**BEFORE
THE PUBLIC UTILITIES COMMISSION OF OHIO**

In the Matter of the Application The East)
Ohio Gas Company d/b/a Dominion East)
Ohio for Approval of an alternative Form) Case No. 15-0362-GA-ALT
of Regulation.)

**OBJECTIONS TO THE PUBLIC UTILITIES COMMISSION OF OHIO
STAFF'S REPORT OF INVESTIGATION
BY
THE OFFICE OF THE OHIO CONSUMERS' COUNSEL**

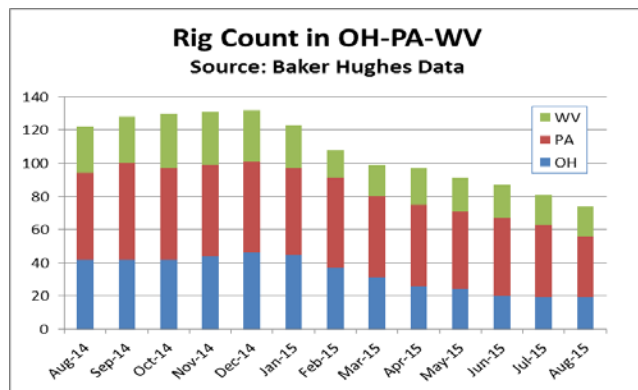
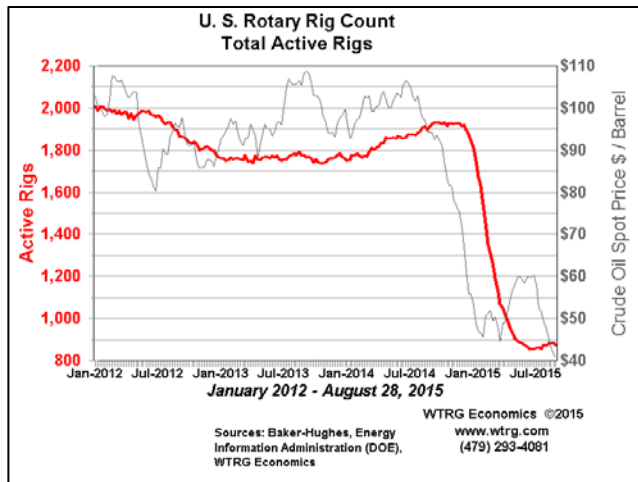
The pace of oil and gas exploration in the Midwest (and elsewhere) has definitely diminished, as reported in the August 19, 2015 Wall Street Journal¹⁶ and demonstrated in the graphs below¹⁷ showing the dramatic reduction in rig count in the US in the last eight months, and how this also resulted in an over-50 percent reduction in the rig count in OH and a 44 percent reduction in the rig count in the OH-PA-WV area. The chart for the total U.S. also shows the price of oil, and how the rig count directly reacts, with a lag of a few months, to the price of oil, and that even a rise of the price of oil to \$60 per barrel from \$40 per barrel was not a significant stimulus to the rig count. It would appear that it would take the return of near-\$100 per barrel oil pricing to return the rig count to 2012-2014 levels.
